Before the Board of Inquiry  
Waterview Connection Project

Rebuttal evidence of **André Walter (Construction)** on behalf of the  
**NZ Transport Agency**

Dated: 3 February 2011

<b>VENT - NORTH</b>	<b>DWG 002</b>
<b>RAMP OPTION- PLAN</b>	Scale 1:1000@A4

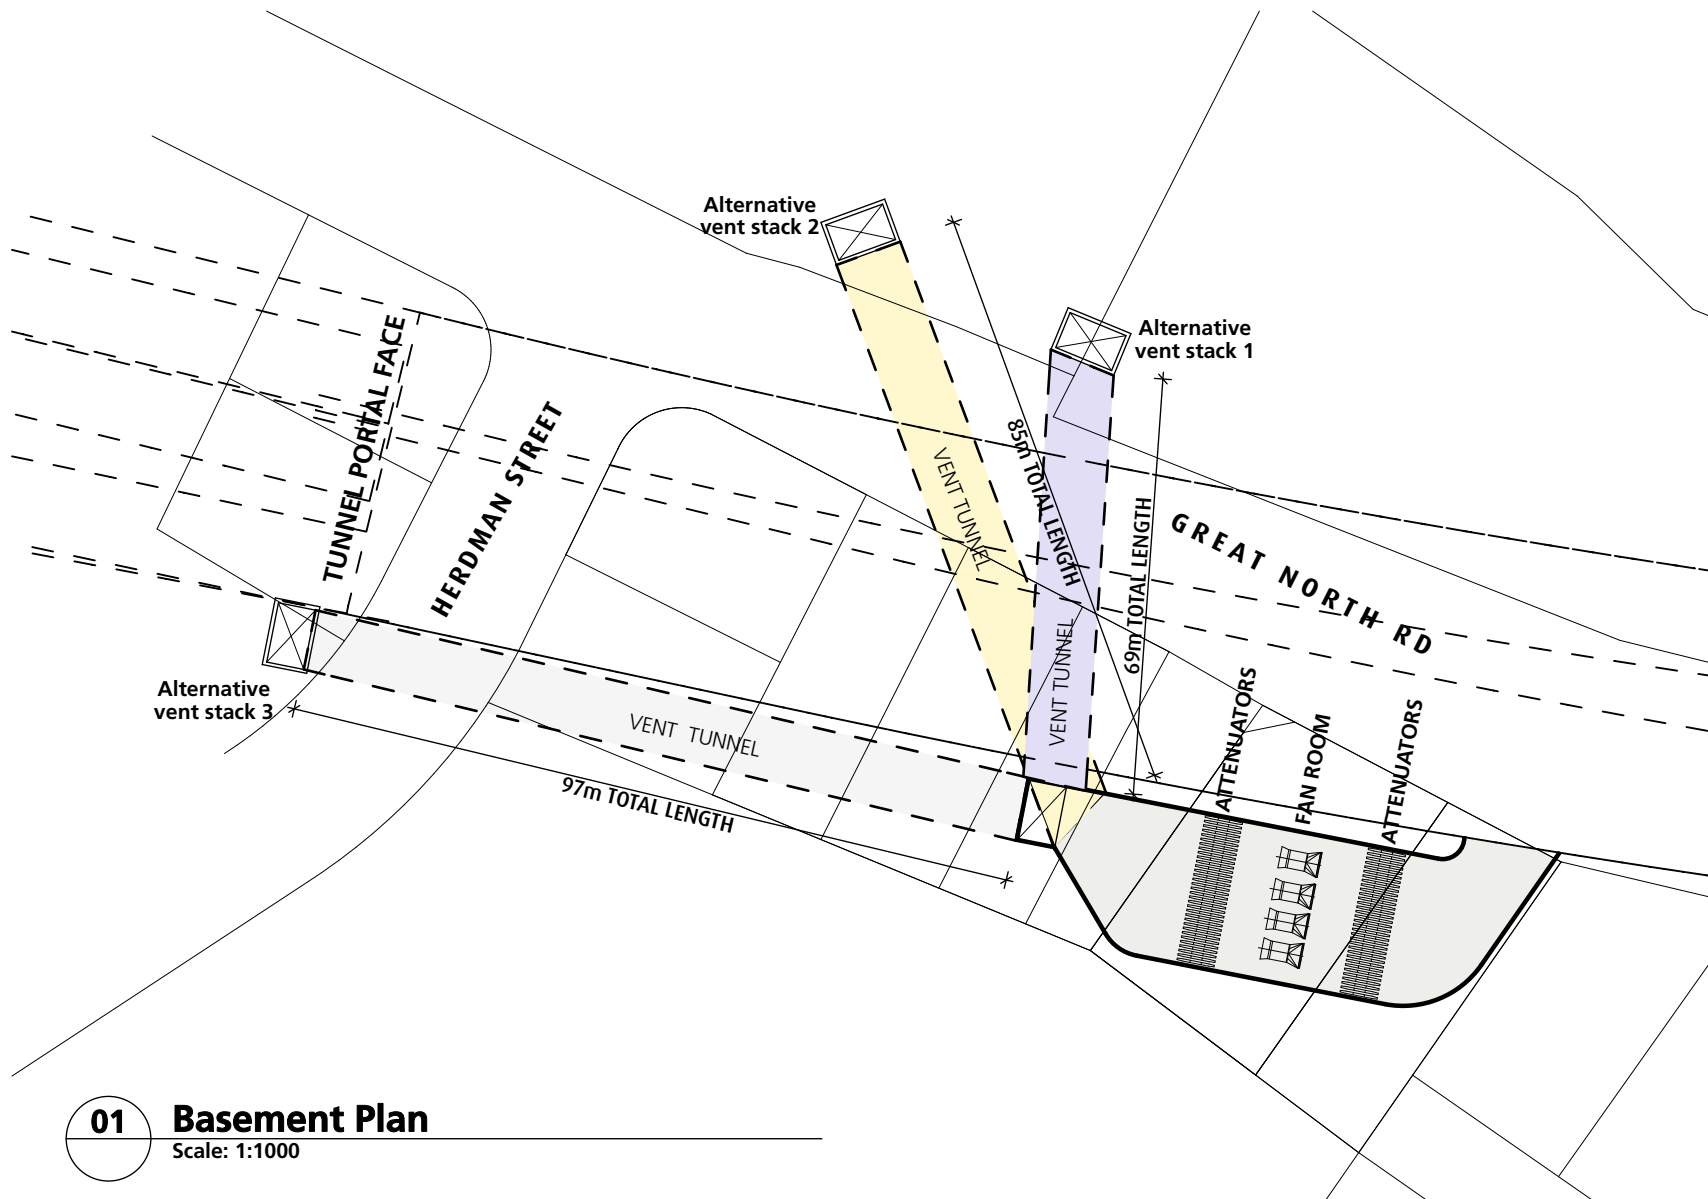
- 18 The Drawing Vent North 002 attached as **Annexure C** indicates how this access ramp would need to be constructed to enter the buildings below ground.

- 19.5 To obtain access with a 10t lowbed truck which would be used for transporting the equipment, Points B and C shown on Drawing Vent North 002 must be at the same level. 150m is available between Point A and Point B, shown on Drawing Vent North 002, and within this length the road would have to decline 14m.

- 19.6 This results in a grade of 9.3% over this distance, which is too steep for safely dealing with heavy vehicles over the short distance and would result in a very sharp curve at the bottom of the decline.

<b>VENT - NORTH</b>	<b>DWG 004B</b>
<b>ALTERNATIVE STACK LOCATIONS</b>	Scale 1:1000@A4

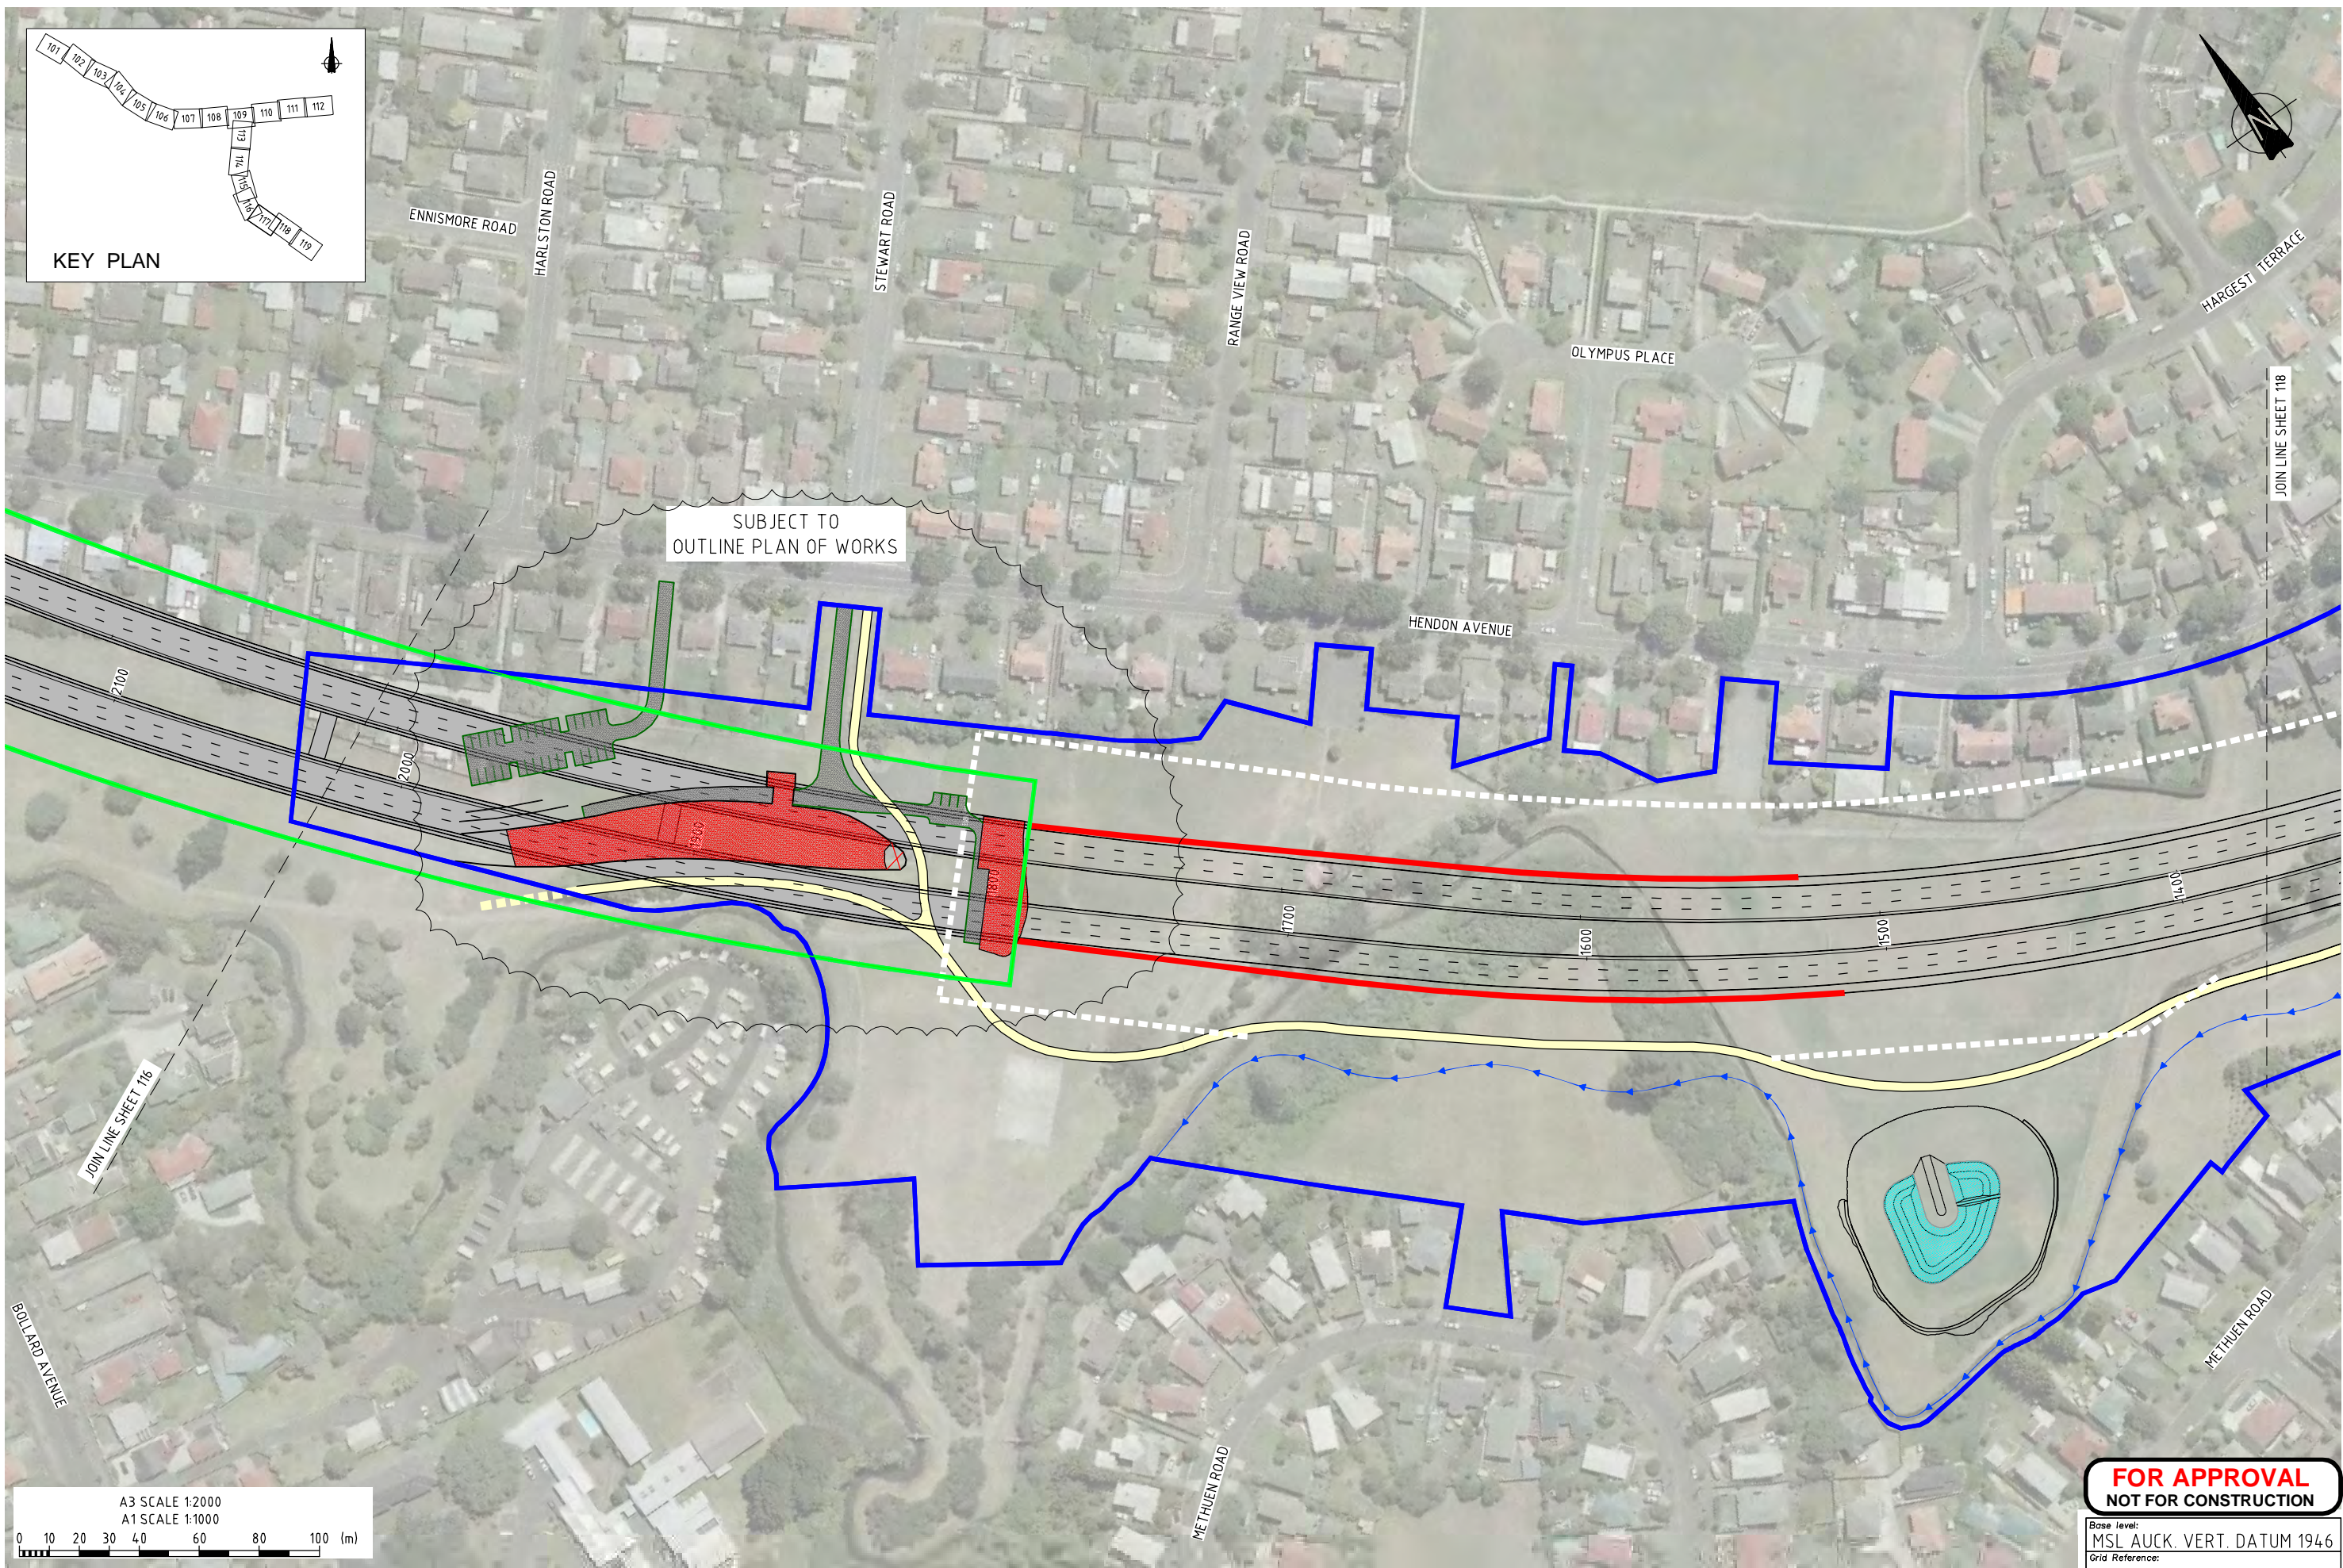
- 28 **Following the NZTA's review of the submitters' evidence**, three locations have been reconsidered as shown in Drawings Vent North 004A and 004B included in **Annexure E**, these being:<sup>11</sup>

- 32.2 Locating the ventilation stack adjacent to the BP Filling Station (Alternative 2) would place the stack within a low lying area that is currently covered with established vegetation (as can be seen from the Drawing Vent North 004B within **Annexure E**). To construct the ventilation stack within this area would require 80m<sup>2</sup> of vegetation to be cleared to allow for the construction of the foundation and erection of the stack.

<b>VENT - SOUTH</b>	<b>DWG 001</b>
<b>UNDERGROUND OPTION</b>	Scale: 1:1000@A4

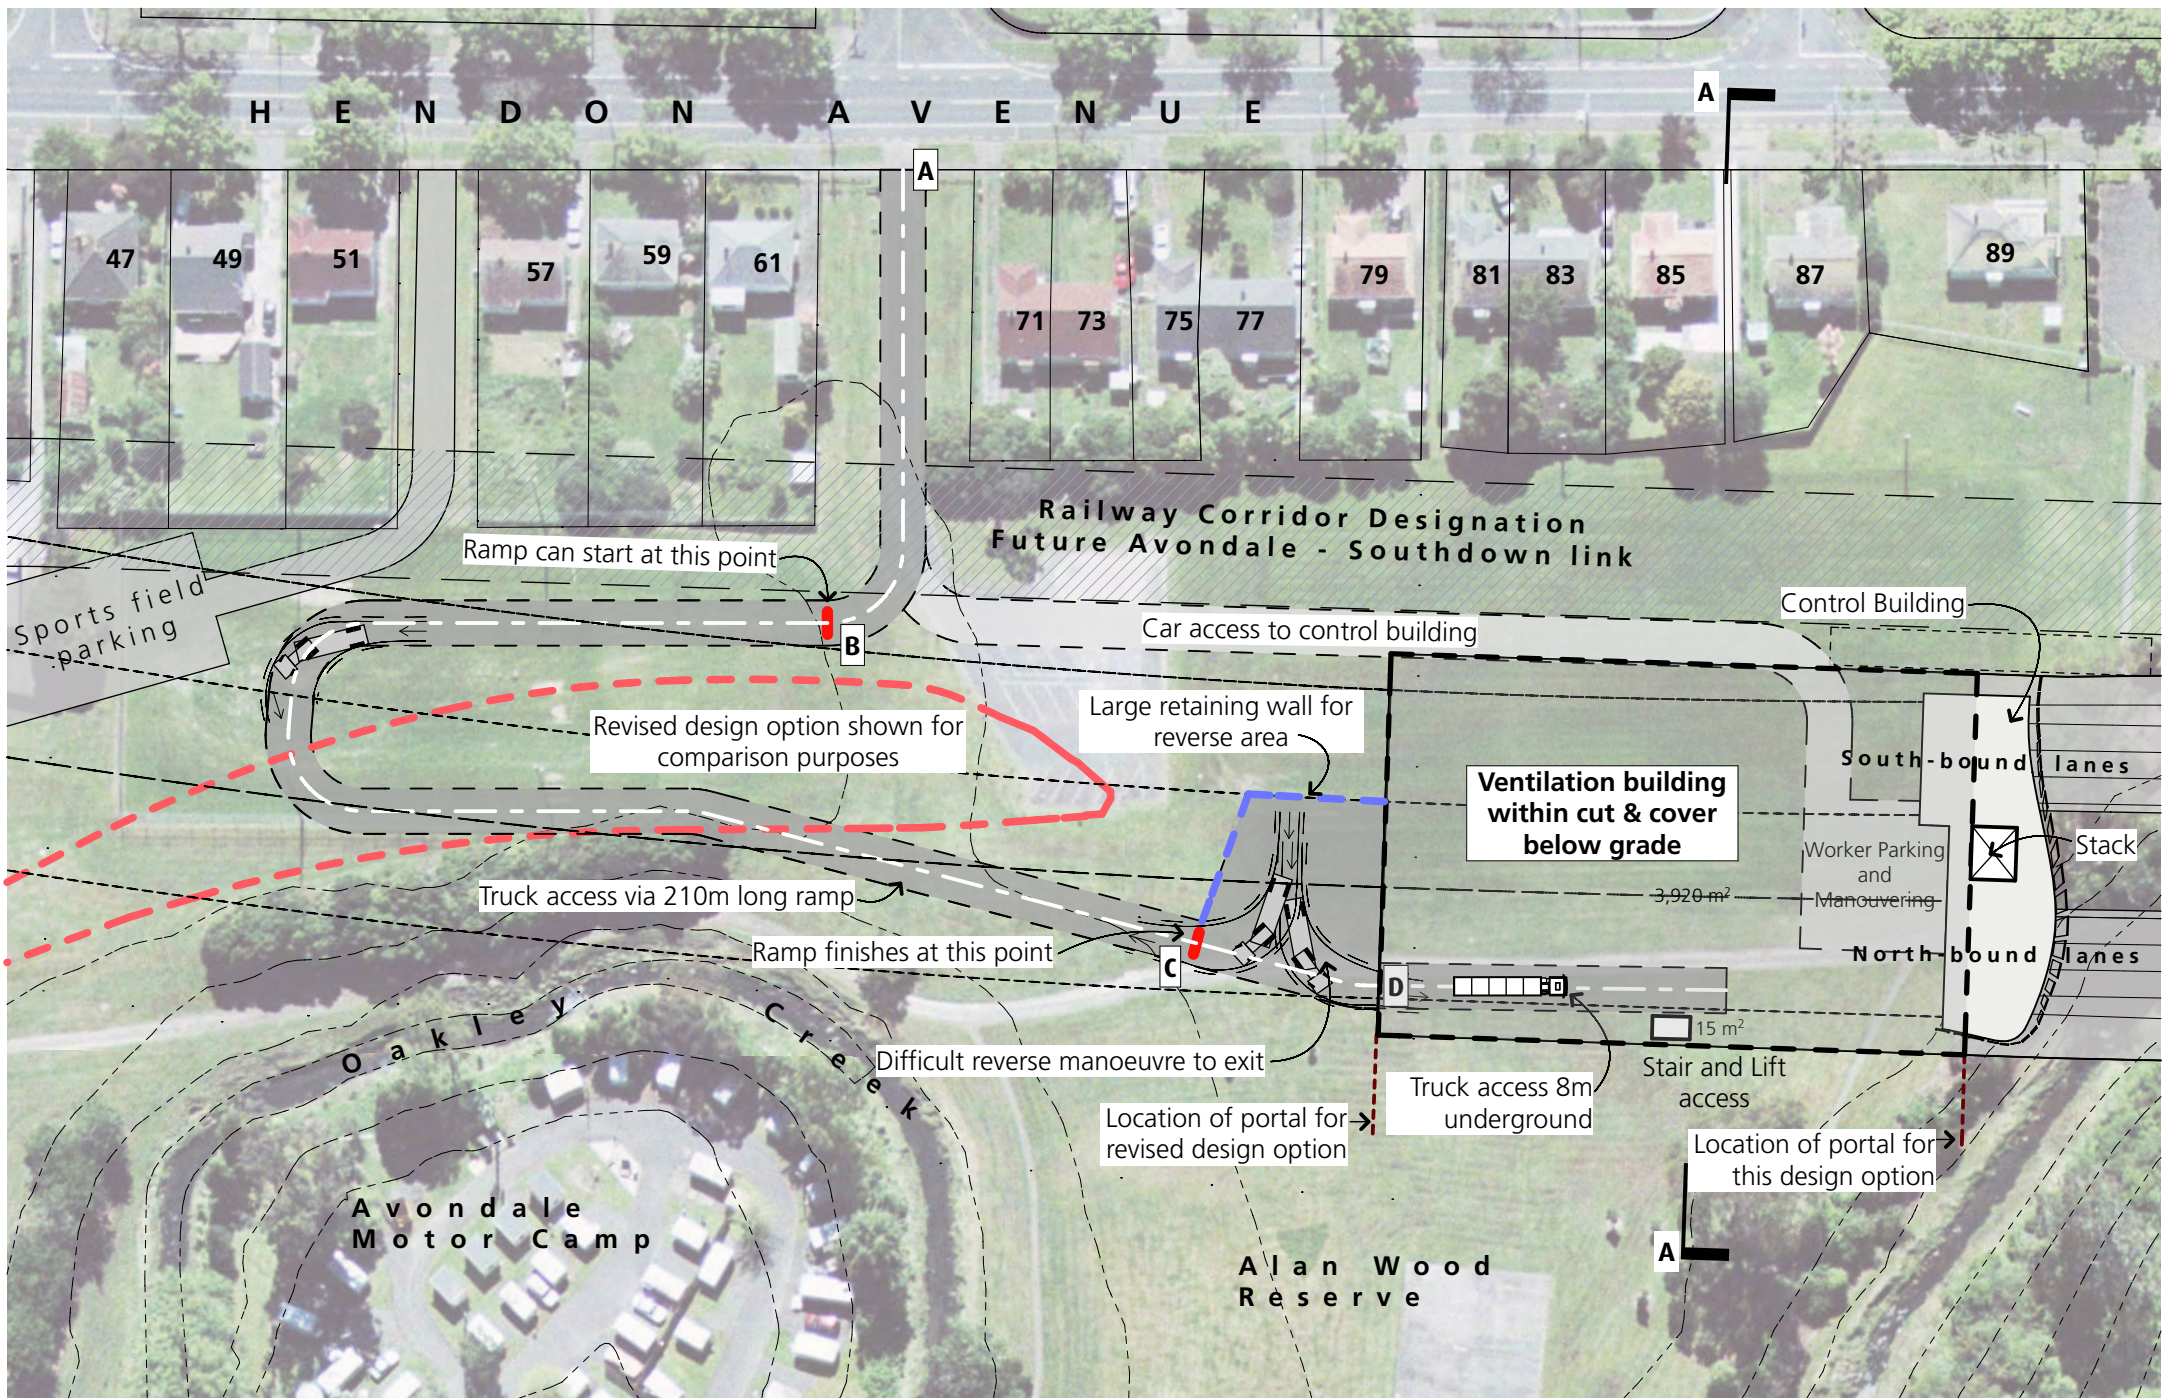
- 47 This option is shown within Drawings Vent South 001 and a cross section shown on Drawing Vent South 001a attached as **Annexure G**. It places the building completely within the deep cut prior to the driven tunnel portal.

- 48 Drawing Vent South 001 (**Annexure G**) shows that:
- 48.1 An access ramp of 210m maximum length can be provided between points B and C. This is deemed to be the minimum length that could be accommodated without increasing the amount of land required from within the Alan Wood Reserve for the access road.

<b>VENT - SOUTH</b>	<b>DWG 001a</b>
<b>UNDERGROUND OPTION: SECTION AA</b>	Scale: 1:500@A4

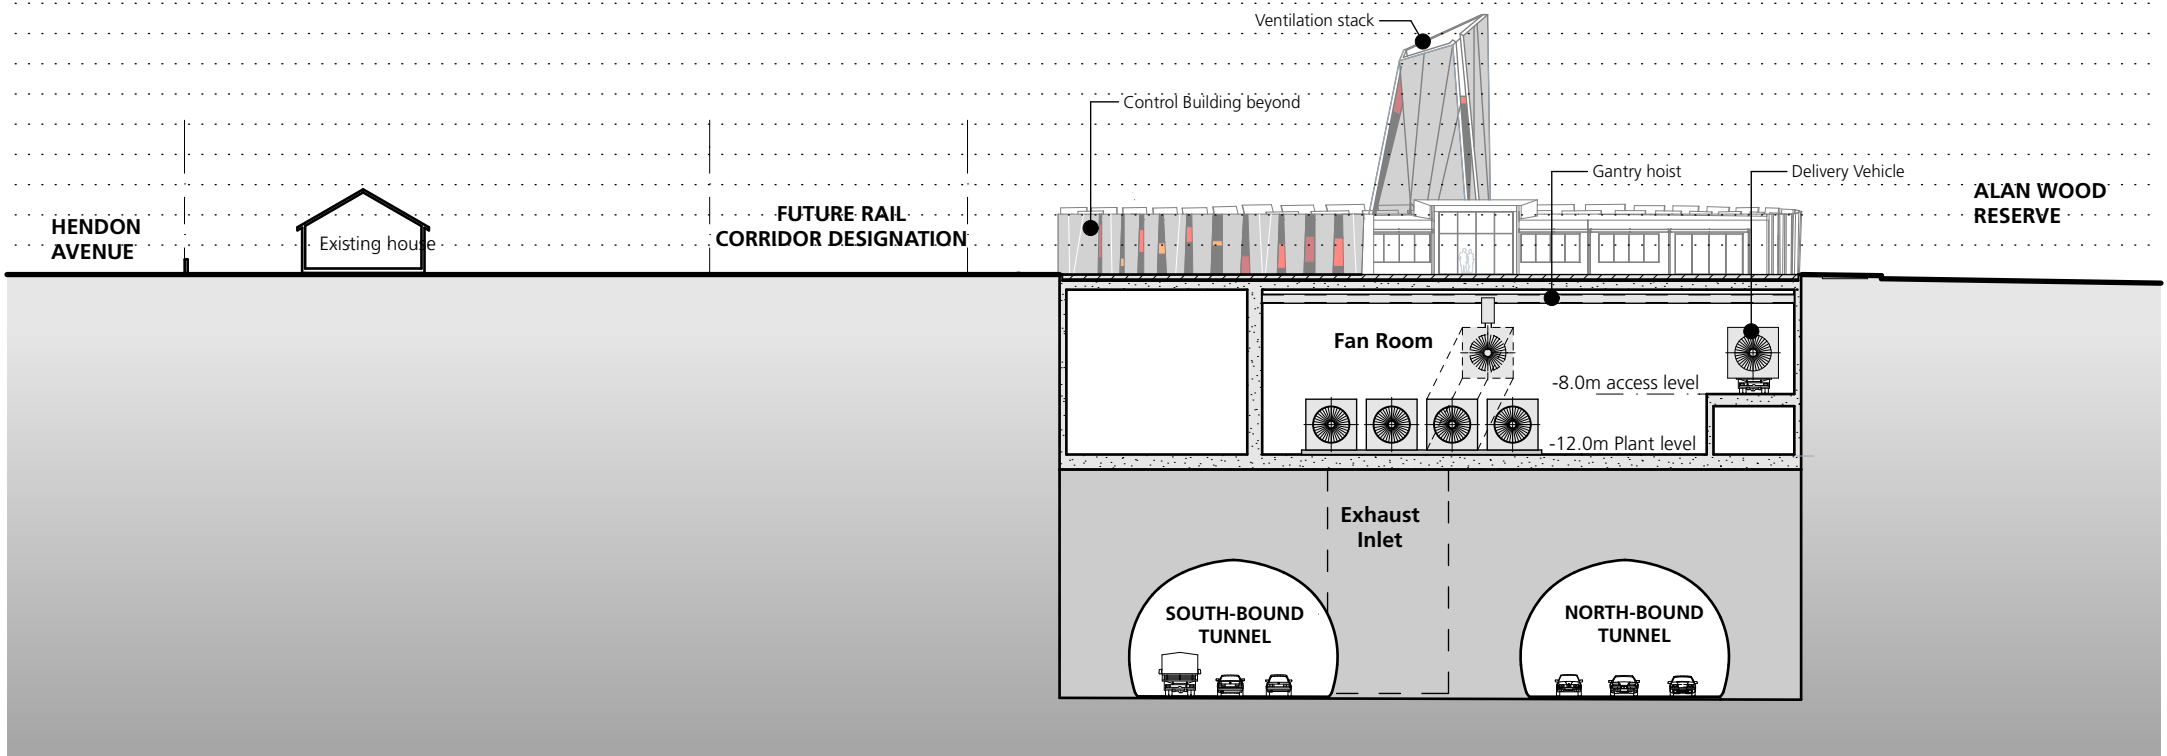
- 48.7 A separate access road and parking areas as shown would have to be provided for the operations centre.
  - 48.8 Removal and replacement of the ventilation fans and power equipment would be undertaken using a gantry crane arrangement (which is shown in Drawing Vent South 001a).
